<b>Date Issued :</b>	August 27, 2024	<b>PCN Number :</b>	515667
<b>Reason for Change :</b>	Packaging Method/Quantity Changing		
<b>Description of Change :</b>	This notification is to inform you about part(s) listed will undergo changes for packaging specification change. No changes will be made to product as part of this change.		
<b>Assessment of Change :</b>	Drop Test		
<b>Planned Implementation Date :</b>	February 28, 2025		
<b>Customer Sample Availability Date:</b>	December 20, 2024		
<b>Last date to request Samples by Customer :</b>	December 20, 2024		
Please note if Samples are not requested as per Customer Samples Request date, it may take additional 4-6 weeks to arrange Samples.

Before Picture

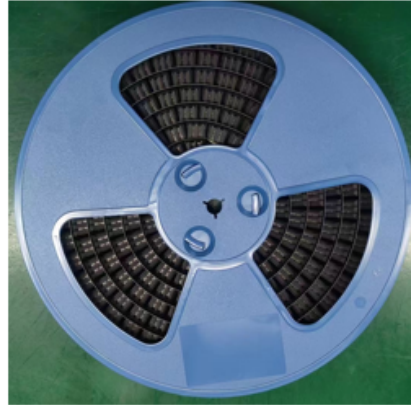
- Change packing tape reel from paper trays to plastic trays

- Change packing tape reel from paper trays to plastic trays for enhance packaging protect capabilities.
